MAINE TURNPIKE AUTHORITY ADDENDUM NO. 1

CONTRACT 2018.03

EXIT 44 SOUTHBOUND ON RAMP IMPROVEMENTS
MILE 44.3

SHEET NUMBER: 2 OF 64

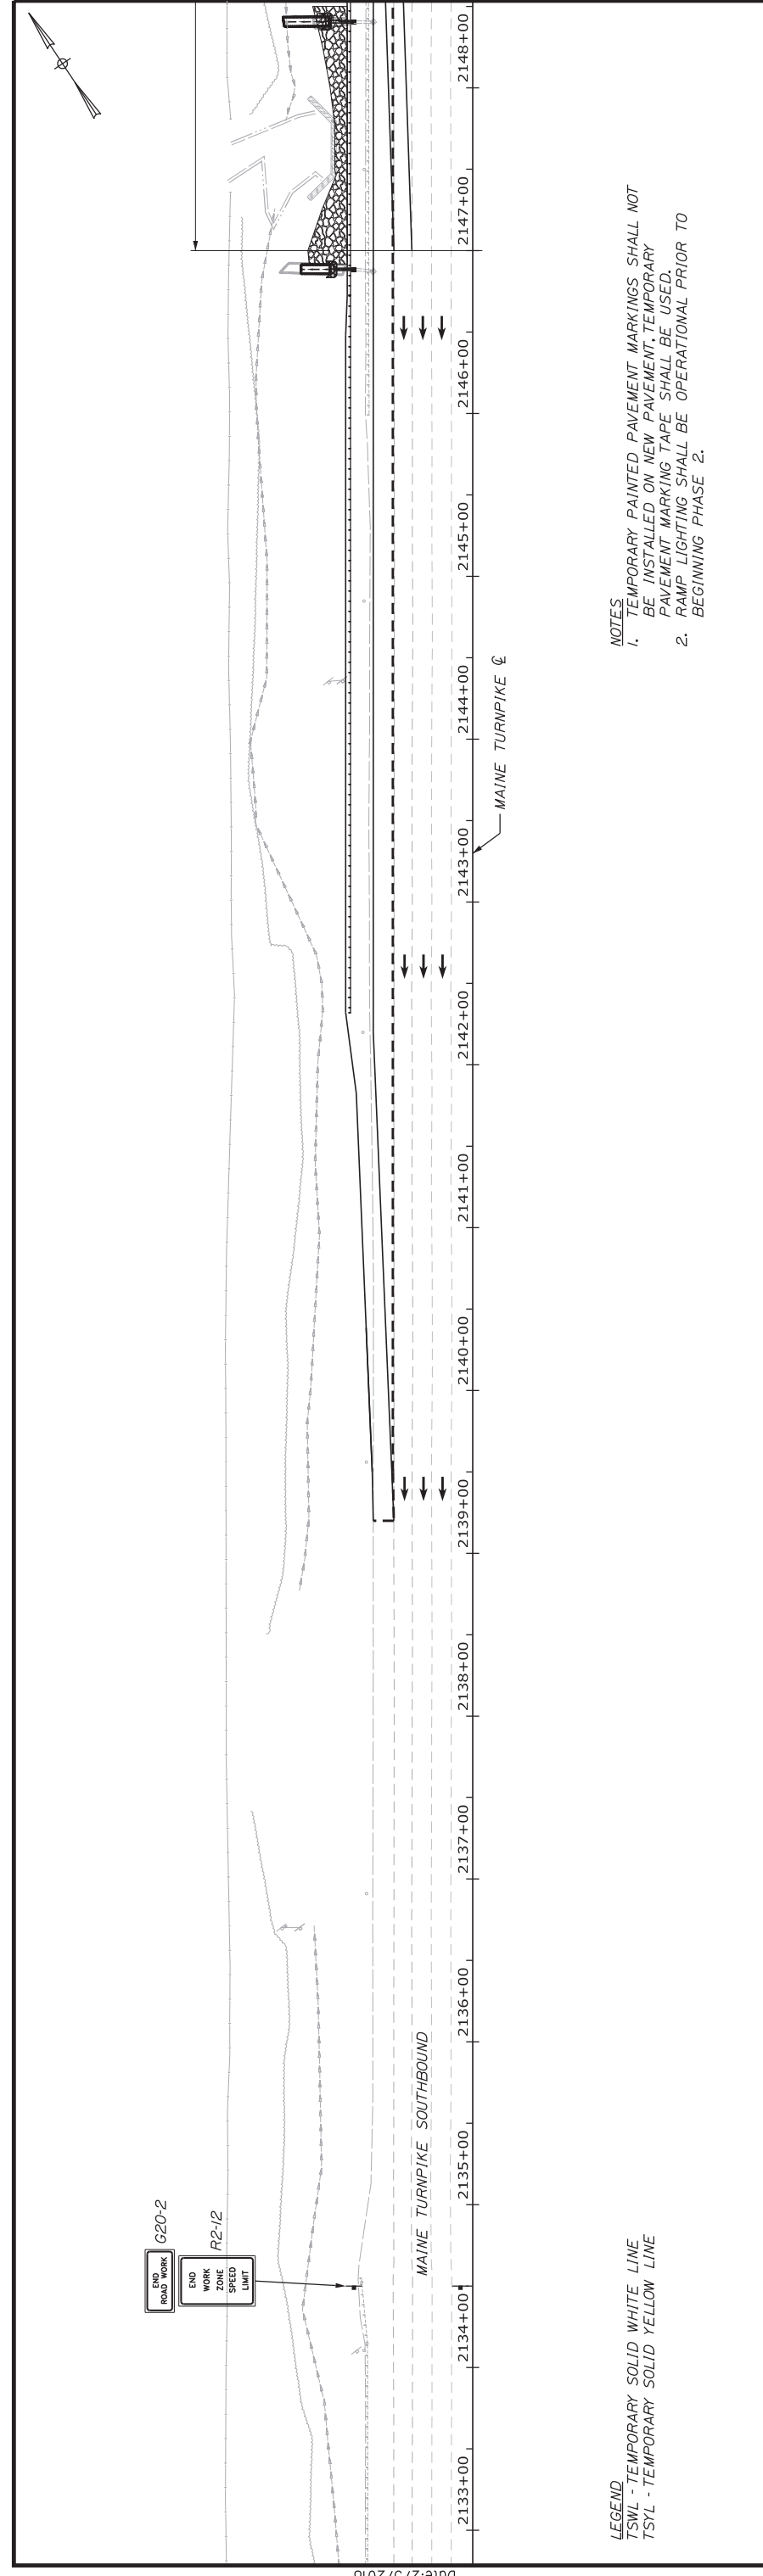
- Proposal Sheets P-2 to P-9 are deleted and replaced with sheets P-2 to P-9 attached hereto. The revision to these sheet adds the item 403.211 Hot Mix Asphalt - Shim

Answer: Shimming will be paid for under item 403.211 Hot Mix Asphalt - Shim. This addendum will add item 403.211.

POLE TOP SINGLE SPOKE BRACKET ARM
NOT TO SCALE

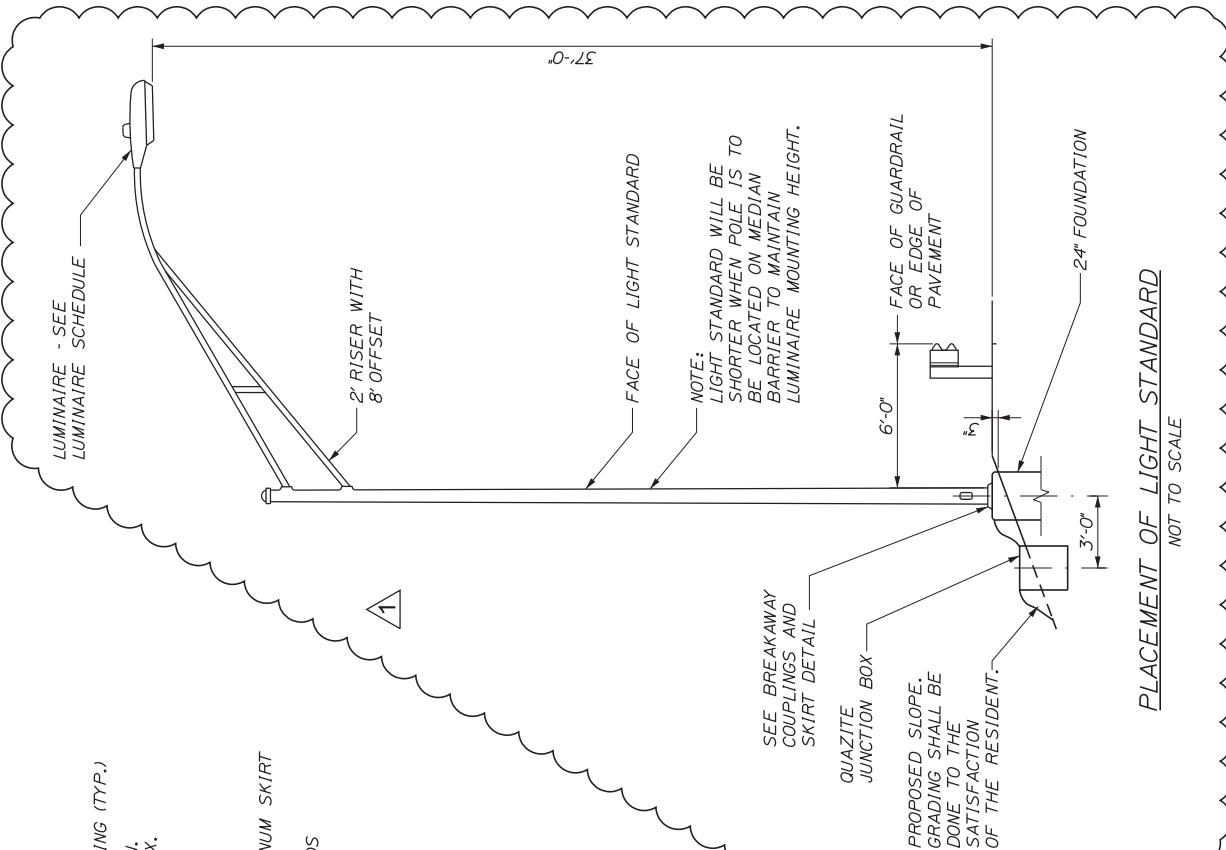
- SP-67, SECTION 634 HIGHWAY LIGHTING, Section 634.01, fourth paragraph is deleted and replaced with, “All new light standards will be 35 feet tall with 2-foot riser and a 8-foot offset arm as detailed in the plans. All highway lights shall be installed so the LED fixture is centered over the shoulder for maintenance purposes.”
